```
SUBJECT: PLANS AND PROPOSAL ADDENDUMS
      PROJECT: C 916-28-71
                                      CONTROL: 0916-28-071
      COUNTY: SAN PATRICIO
       LETTING: 03/07/2023
      REFERENCE NO: 0227
                         PROPOSAL ADDENDUMS
  PROPOSAL COVER
X BID INSERTS (SH. NO.: ALL
X GENERAL NOTES (SH. NO.: ALL
X SPEC LIST
              (SH. NO.: 3, 4
  SPECIAL PROVISIONS:
  ADDED:
      DELETED:
X SPECIAL SPECIFICATIONS:
  ADDED: 1004
      DELETED:
X OTHER: PLAN SHEET AND OTHER CHANGES
DESCRIPTION OF ABOVE CHANGES
(INCLUDING PLANS SHEET CHANGES)

***** BID INSERTS *****
REVISED QUANTITY FOR THE FOLLOWING BID ITEMS:
     316-6001, 316-6413, 316-6427, 316-6430
ADDED THE FOLLOWING BID ITEM:
     134-6005, 1004-6002
DELETED THE FOLLOWING BID ITEMS:
     134-6006

***** GENERAL NOTES *****
REPLACED ALL SHEETS
**** SPEC LIST ****
ADDED ITEM 1004
***** PLAN SHEETS *****
DESCRIPTION OF ABOVE CHANGES
                                                               (CONTINUED)
```

- SHEET 2 (INDEX): ADDED SHEET 71
- SHEET 3 6 (TYPICAL SECTIONS): REVISED DETAILS
- SHEET 7, 7A 7E (GENERAL NOTES): REVISED NOTES
- SHEET 8 (ESTIMATE & QUANTITY): REVISED FOR ABOVE ITEMS
- SHEET 9 (GO

GOOSE ISLAND STATE PARK TYPICAL SECTIONS

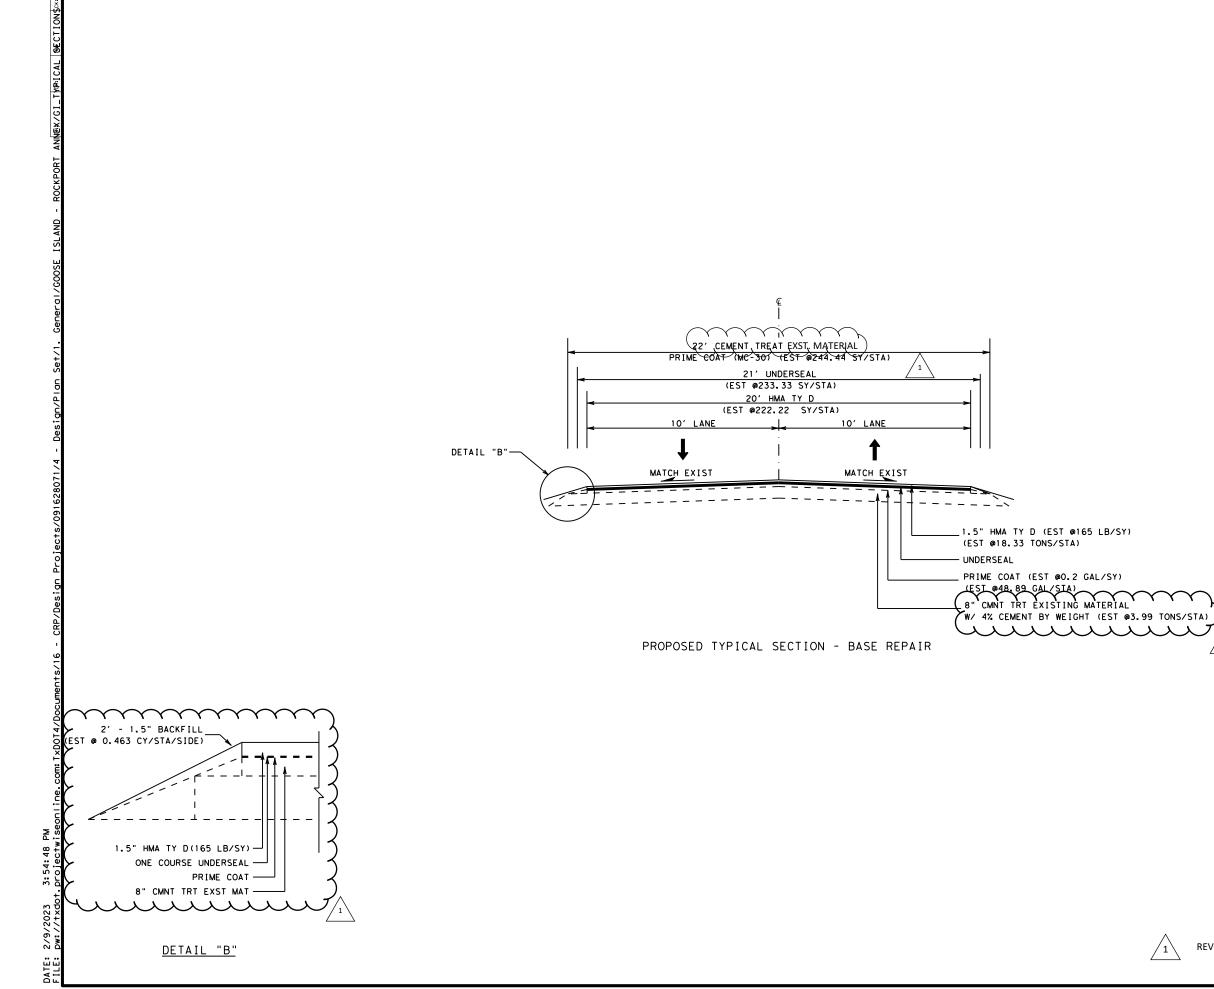
REVISED FEB 21 2023

PROPOSED TYPICAL SECTIONS - CAVE SWALLOW EXTENSION

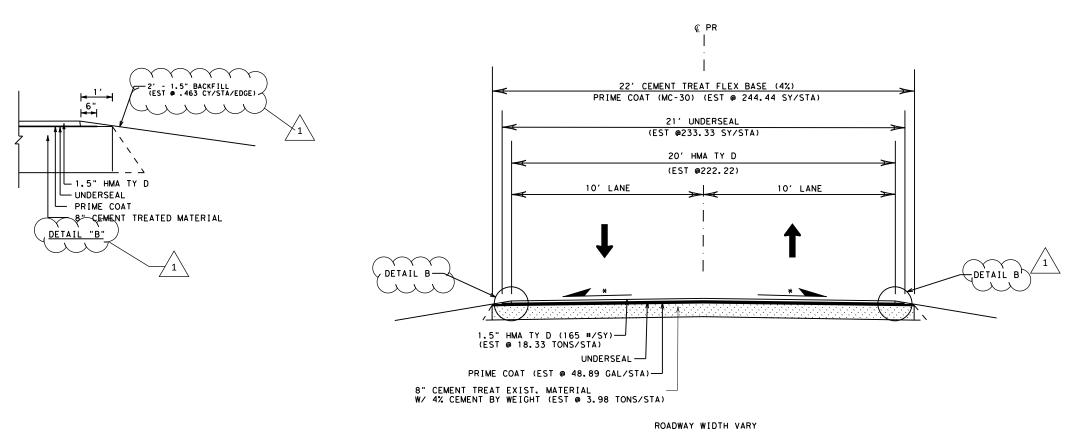
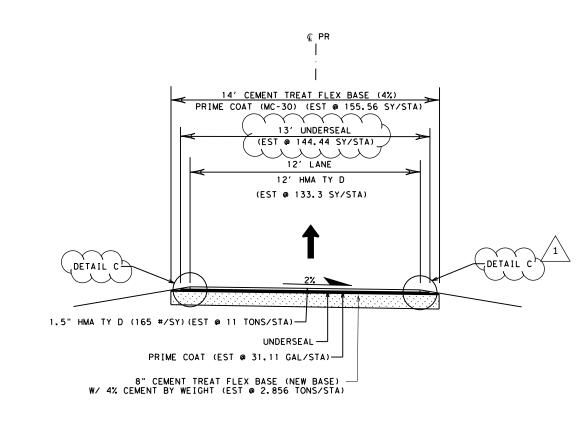
/1\ Revised 2/21/2023

TREE PROTECTION STANDARD SHEET

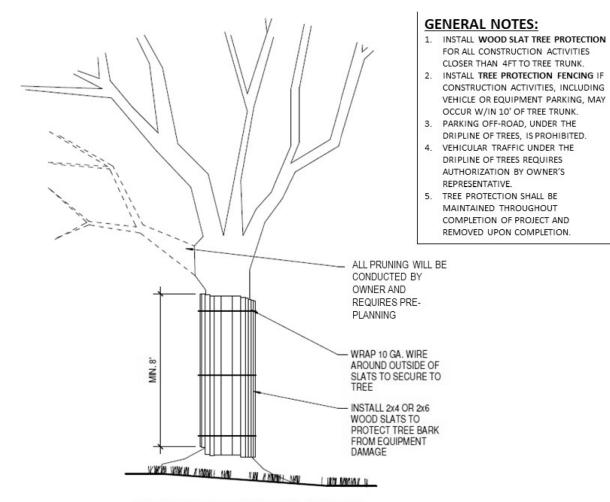
Added 2/21/2023
